Addendum Review of Environmental Factors

Cowra Hospital Redevelopment – Addendum

12 January 2024

Figure 1 Site Layout – Approved Proposal

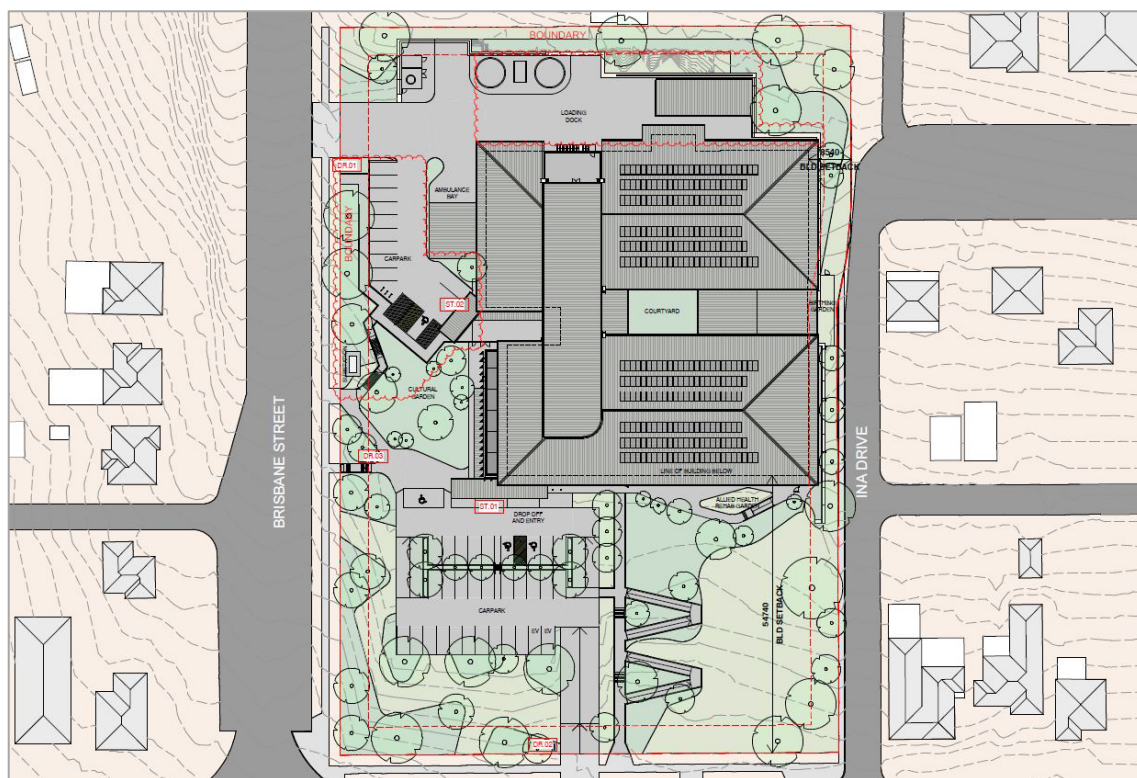
Accordingly, this Addendum REF details the following amendments to the Proposal (the Amended Proposal):

- Revised rear service yard arrangement.
- Amendments to the upper car park and pedestrian pathways, including the conversion of one parking space to a patient transport drop off/pick up space.
- Amended wall and roof configuration at the rear of the hospital.
- Amendments to external awnings.
- Amended landscape design.

Figure 2 illustrates the Amended Proposal's site layout.

Figure 6 Site Layout – Approved Proposal May 2023

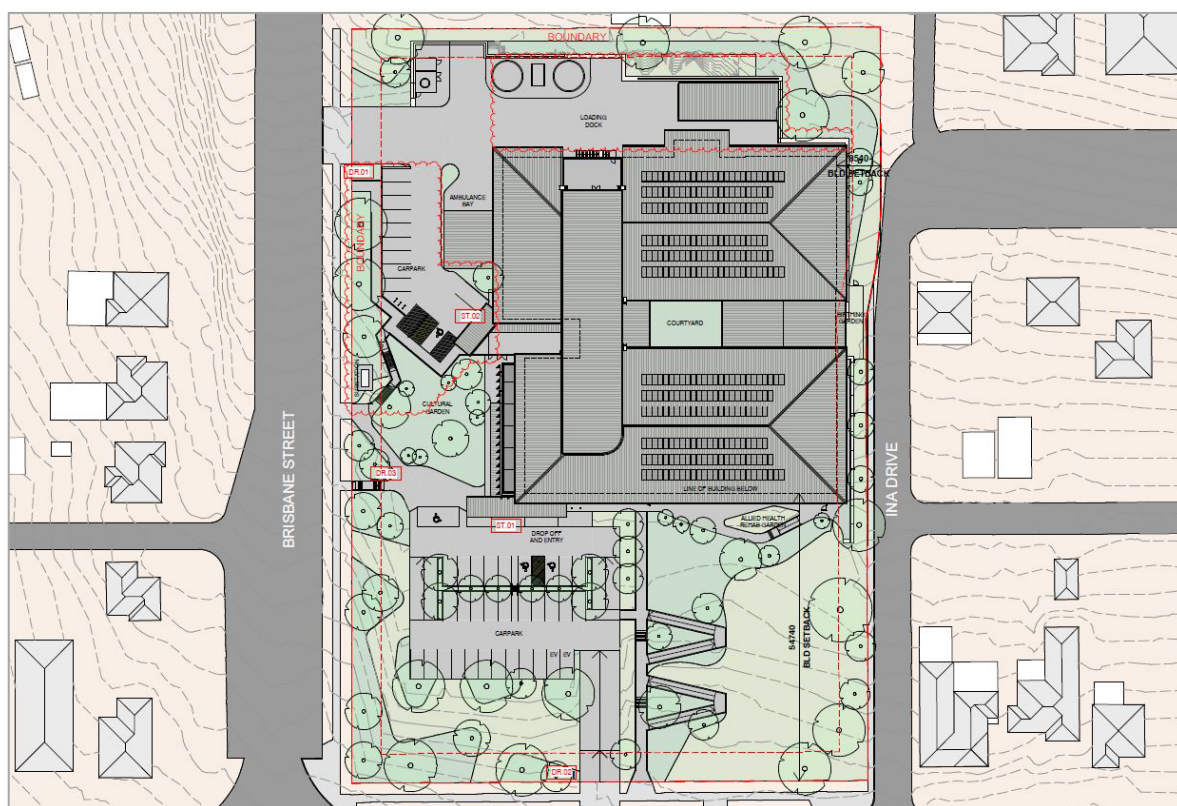
- Revised rear service yard arrangement.
- Amendments to the upper car park and pedestrian pathways, including the conversion of one parking space to a patient transport drop off/pick up space.
- Amended wall and roof configuration at the rear of the hospital.
- Amendments to external awnings.
- Amended landscape design.

Figure 7 on the following page illustrates the Amended Proposal's revised site layout. For comparison, **Figure 6** illustrates the approved Proposal's site layout.

Figure 8 First Floor Plan – Approved May 2023

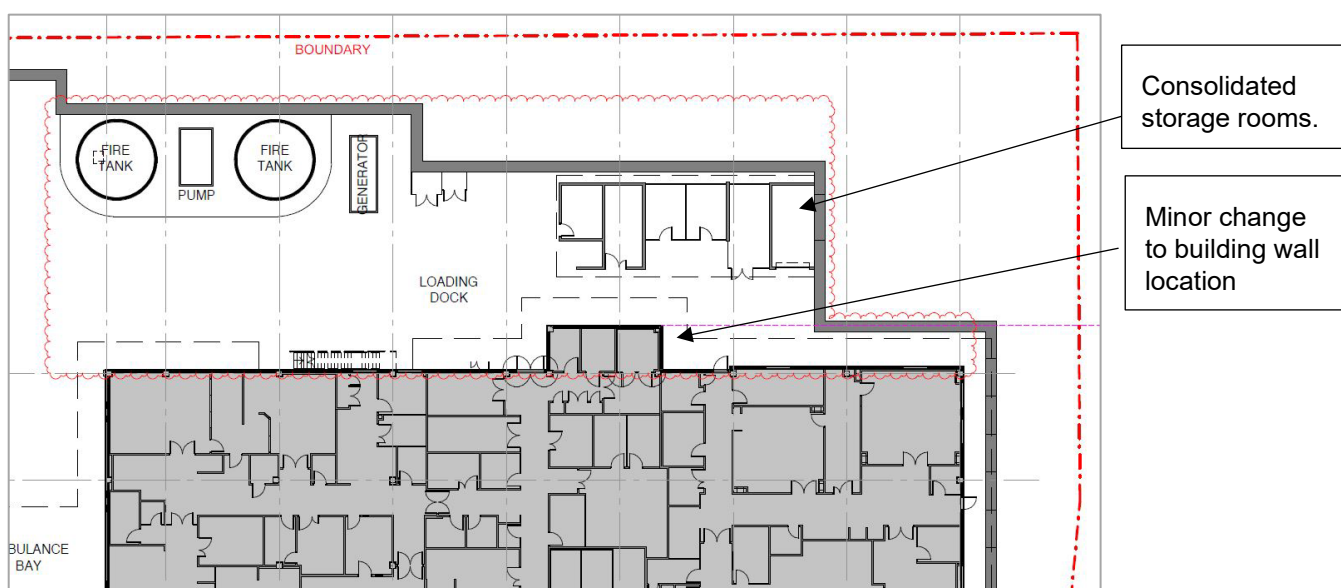
The endorsed Main Works REF approved the construction of a two-storey hospital to the North of the existing hospital. The Proposal included a Tresillian Care unit on the hospital's first floor. The delivery of the unit was removed from the project's scope, enabling a redesign of the hospital's rear layout which increased its separation from the site's northern boundary by approximately 1m (refer to **Figure 8** and **Figure 9**).

The reconfiguration of the rear of the hospital's first floor also enables the rearrangement of the hospital's service yard, including the consolidation of the hospital's equipment wash, general waste, clinical waste and garden storage rooms into a single structure (refer to **Figure 9**).

Figure 10 Upper Car Park Plan – Approved May 2023

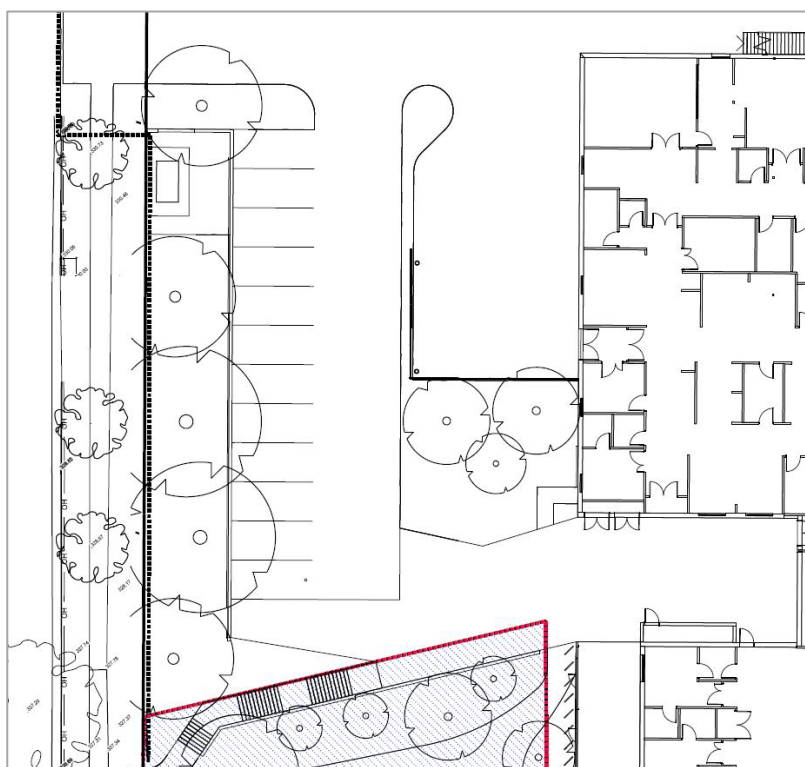
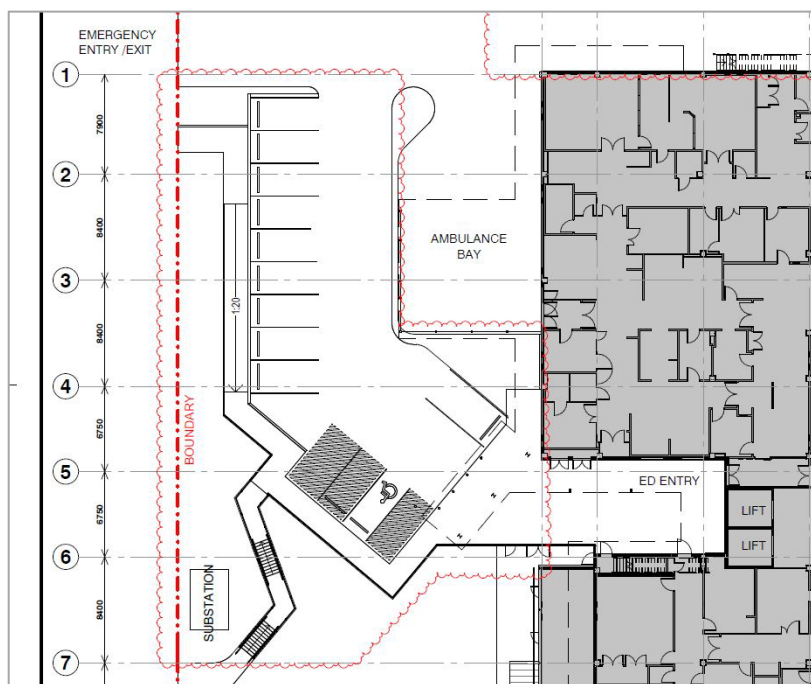
The upper car park included 11 parking spaces, including one accessible space, that are intended to provide after-hours or direct, urgent access parking for the public needing to use the emergency department. This Addendum REF proposes to amend the upper car park's layout to convert one (1) parking space to a drop-off/pick-up space for patient transport vehicles (refer to **Figure 10** and **Figure 11**). This amendment reduces the amount of parking spaces in the upper car park to ten (10) spaces. One of these parking spaces remains as accessible parking.

Figure 12 Southern Elevation – Approved May 2023
Source: DJRD Architects

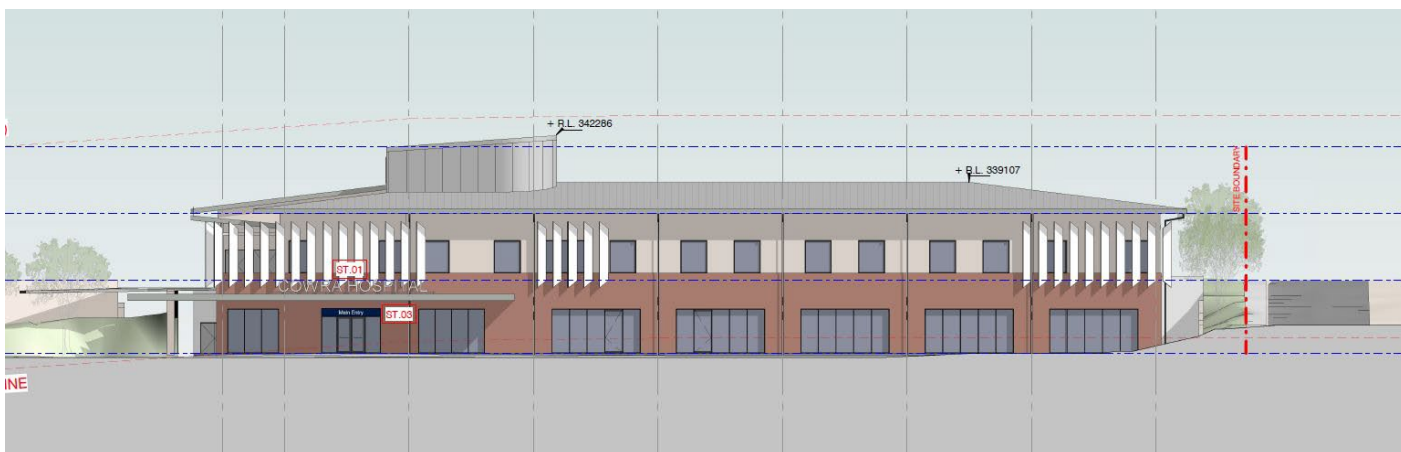
As illustrated in **Figure 12** and **Figure 13**, this Addendum REF proposes to amend the awning design for the hospital's main public entrance. It also proposes minor amendments to the hospital's materiality, including a new upper-level Colourbond external wall finish.

Figure 20 Shadow Diagrams
Source: DJRD Architecture

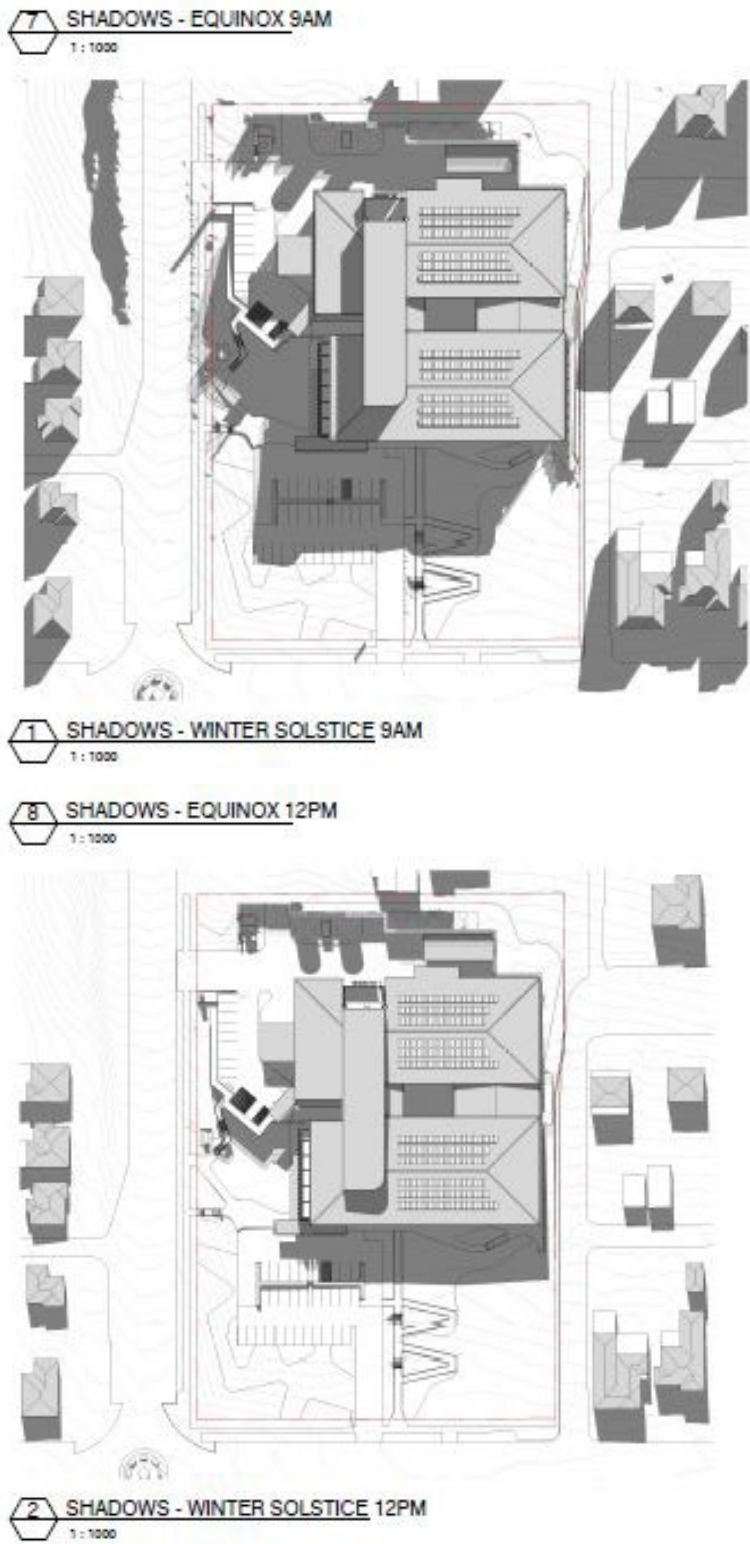
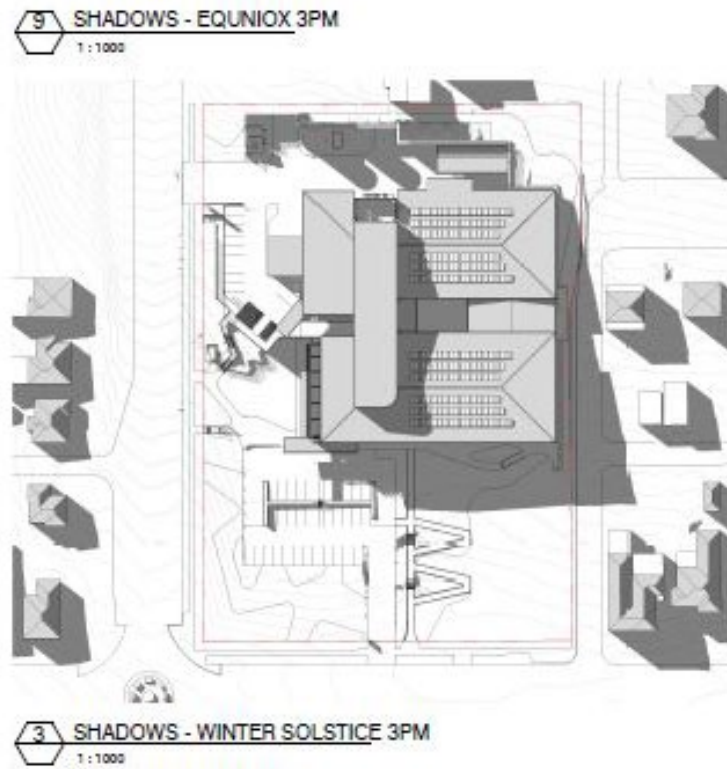
Over-shadowing	<p>The Architectural Drawings include updated shadow diagrams demonstrating that the Amended Proposal will continue to not cause adverse overshadowing impacts to neighbouring dwellings between 9am and 3pm at the Winter Solstice (refer to Figure 20).</p>
